WATER PERMIT NO. 5803-3

Application For Permit To Appropriate Water Within The State Of South Dakota

Re: Lake Menno Dam Reconstruction - Final Review Comments
OFS #GPE931002I
GFP #W94 37 02A

RE: Final Design Documents (#1 Finals)
Repair Lake Menno Dam
Department of Game, Fish & Parks
Menno, South Dakota
OFS No. GPE931002I
GFP No. W94 37 02A
BAI #7626-02

Sketch #3

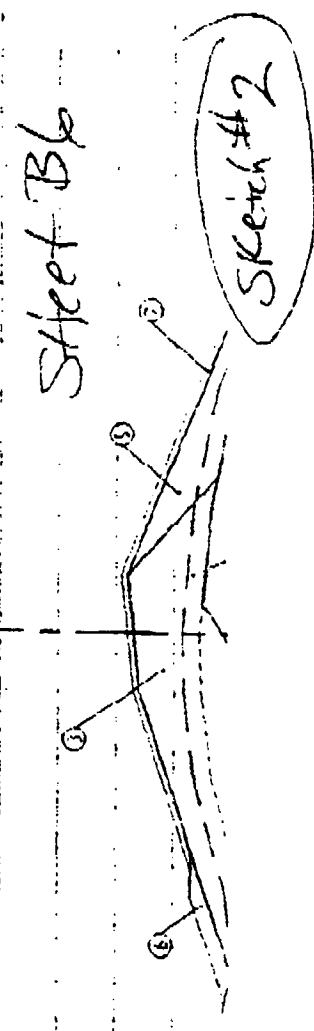
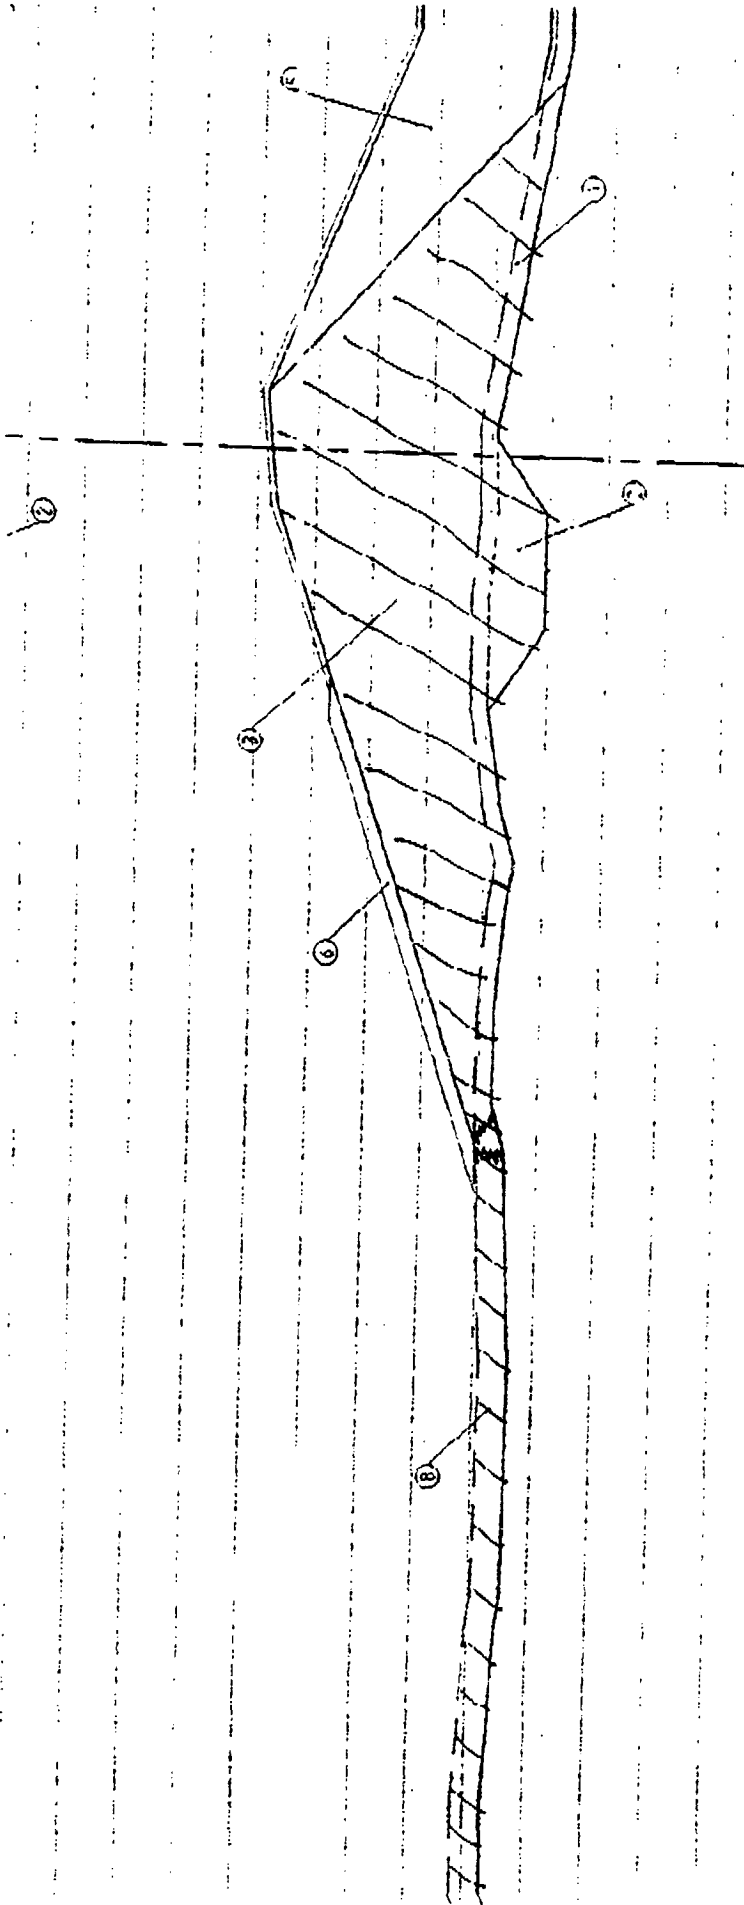
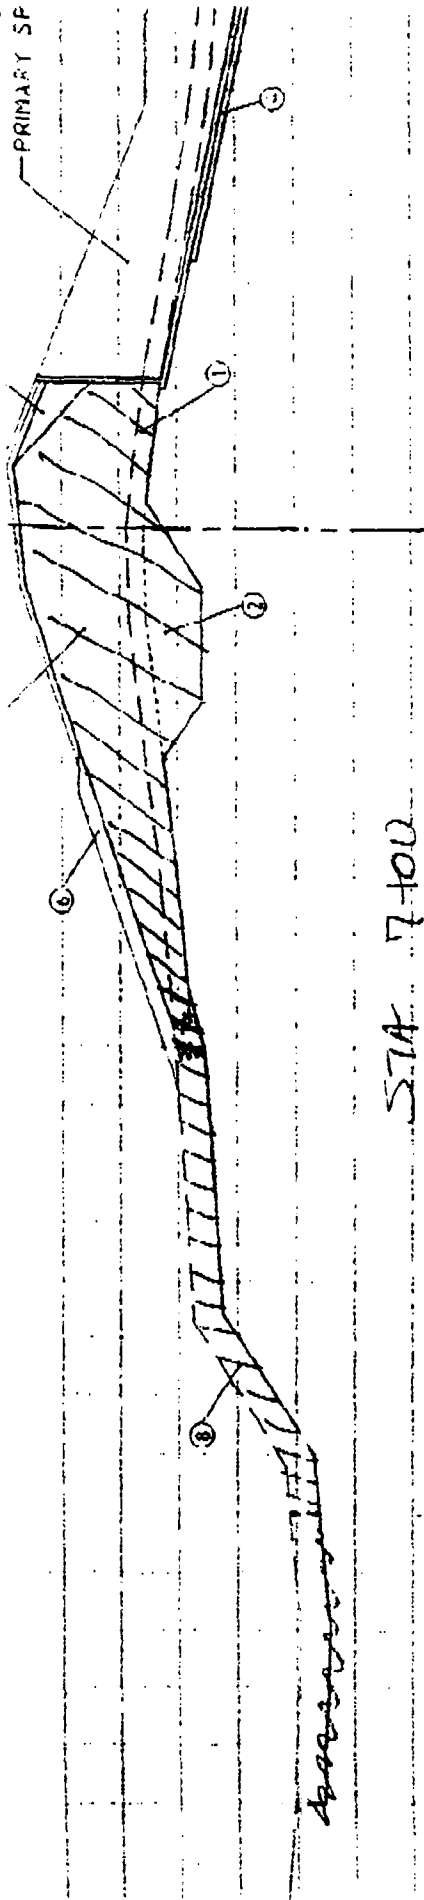
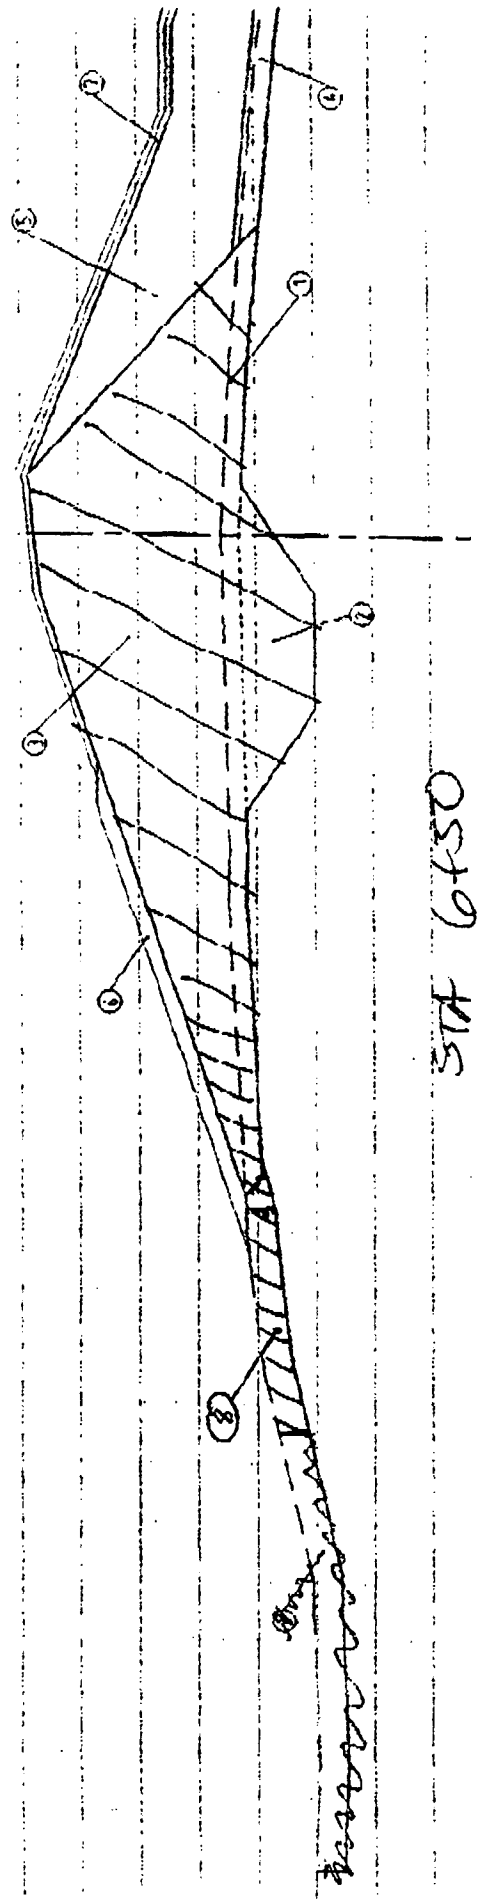
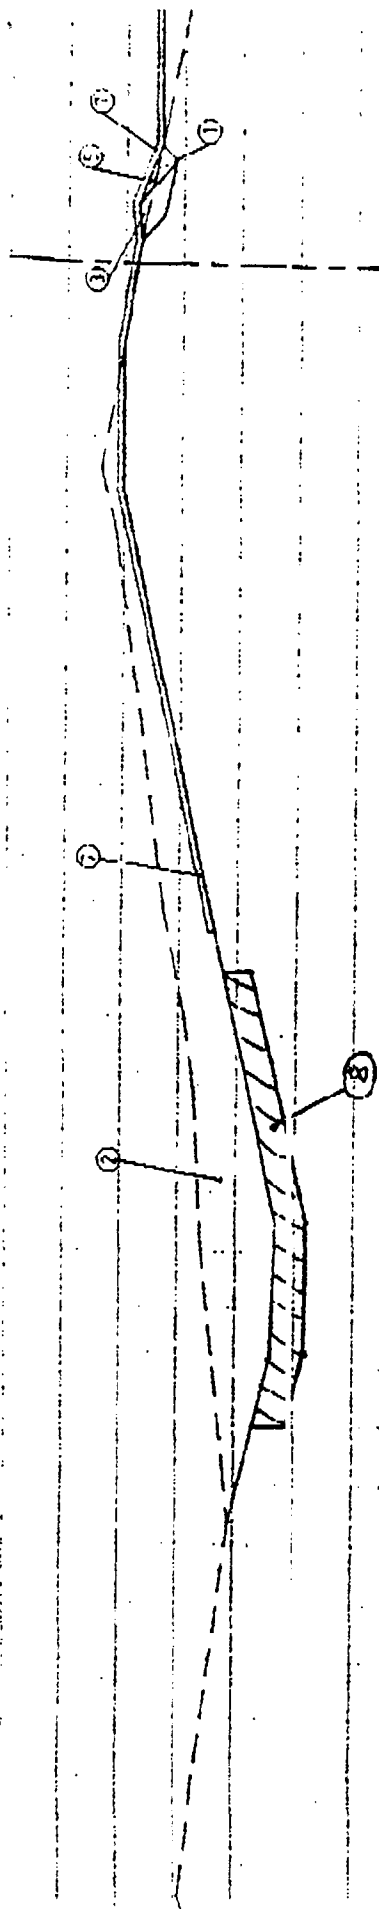
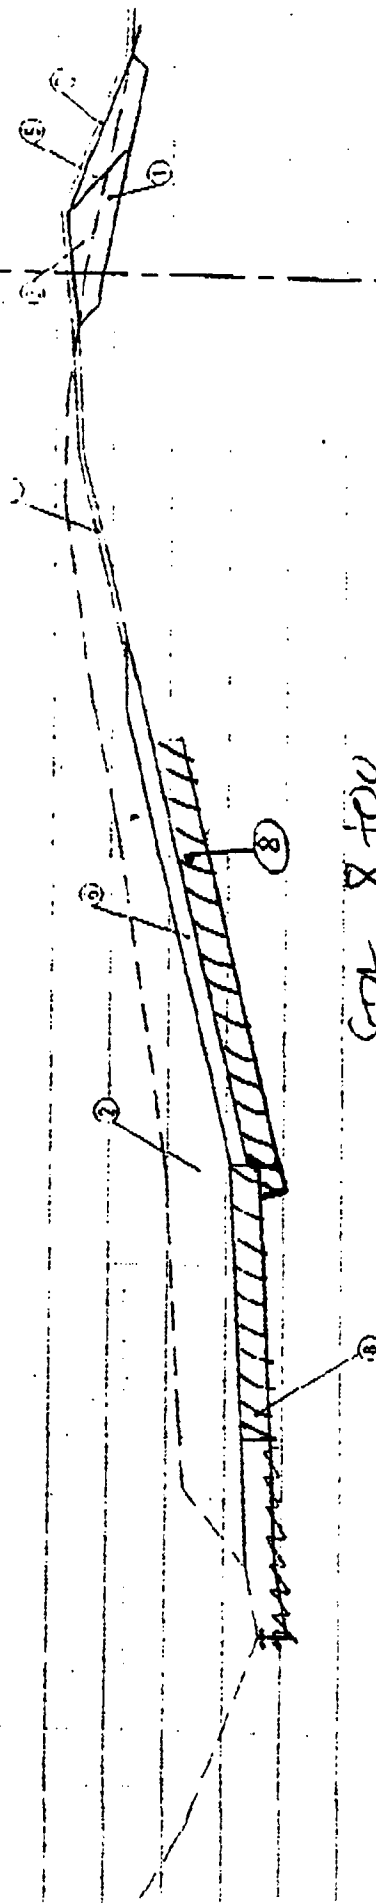
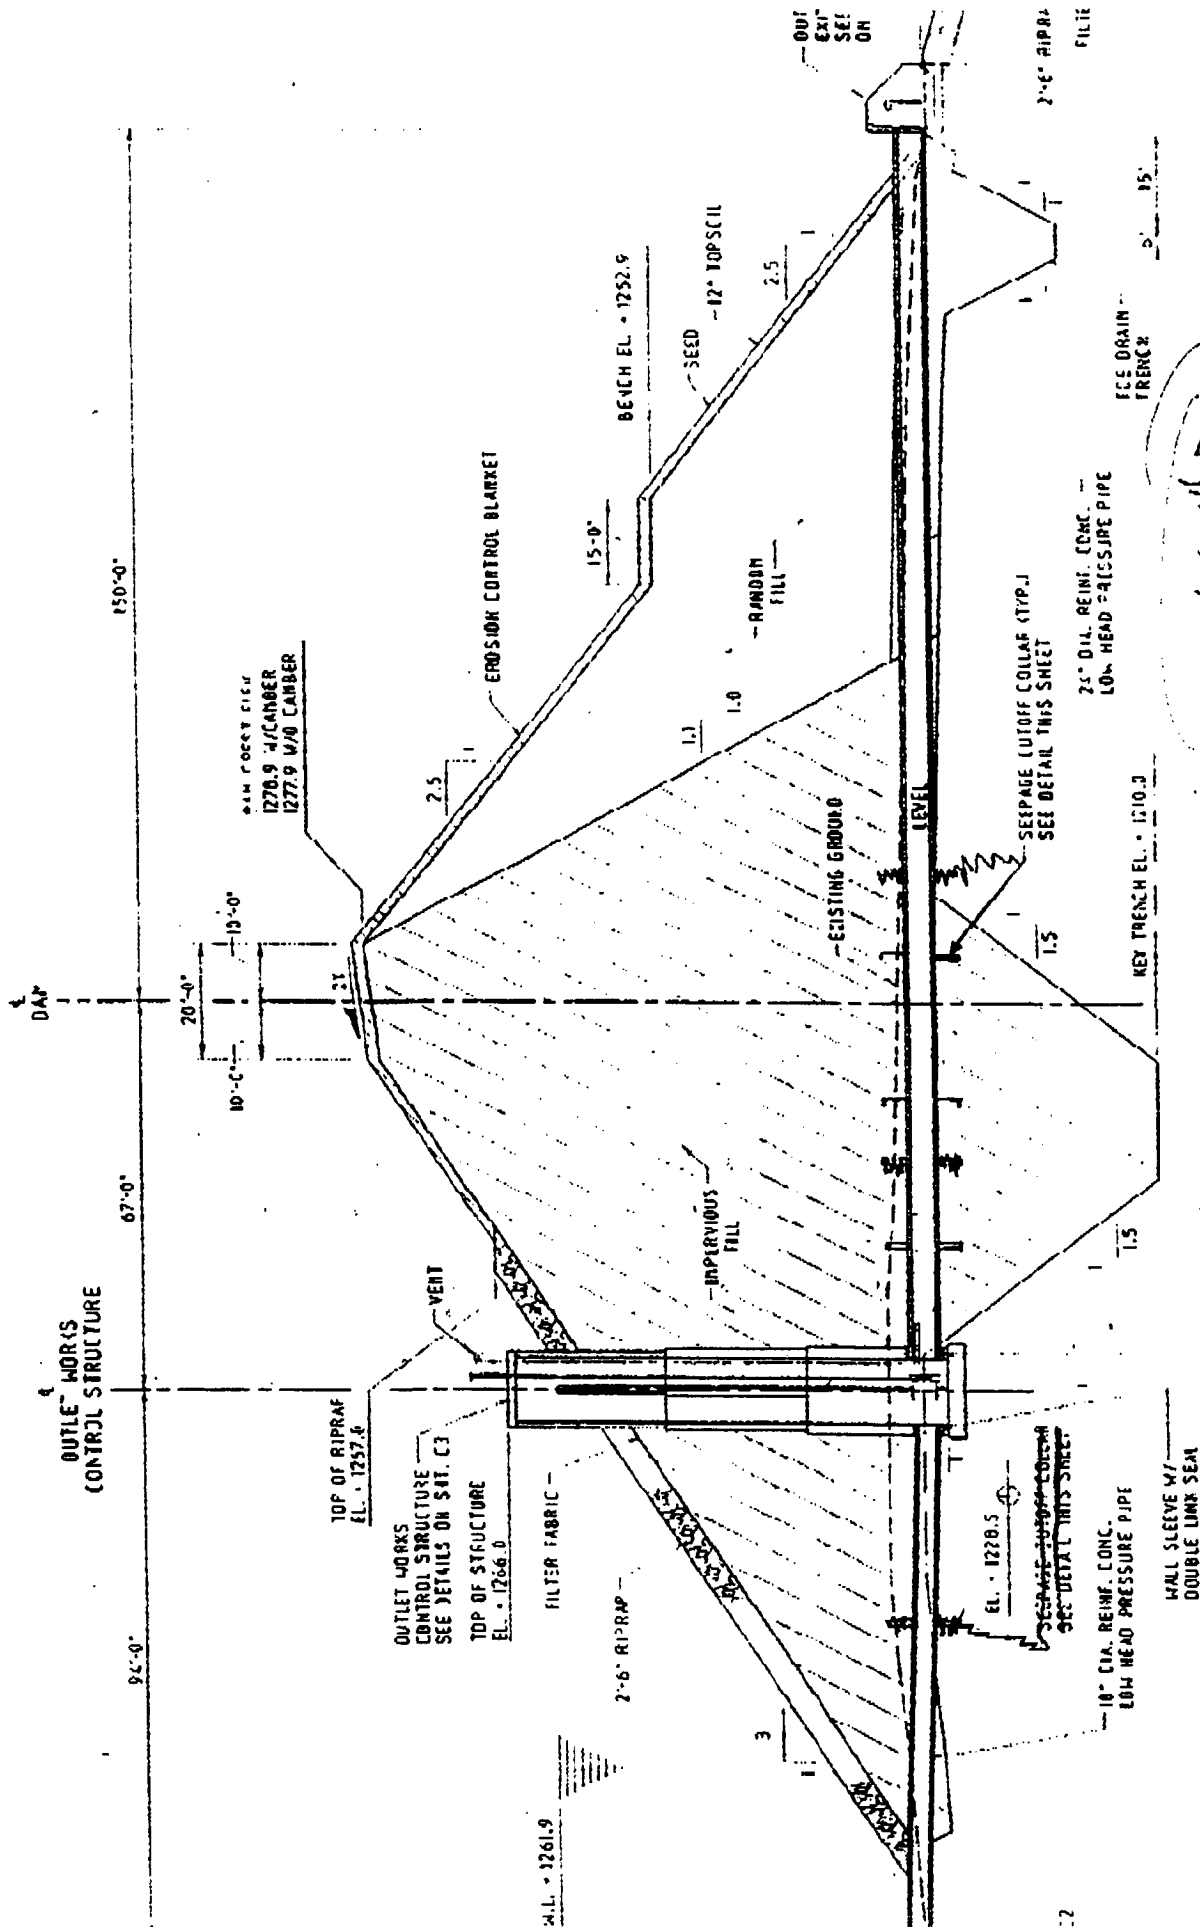
The impervious blanket should be continuous with the clay core of the dam. Therefore, some of the cross sections need to be revised as shown on attached Sketches 2 through 6.

Because of the new limits of the impervious blanket, the cross sections at stations 5+50 and 6+00 would not show the blanket.

- ✓ 2. Revised the limits of the impervious blanket in the cross sections in accordance with review comments from Jim Rudd.
- ✓ 3. Revised the locations of the three seepage collars around the 24" RCP low level draw down pipe on plan sheet C1.
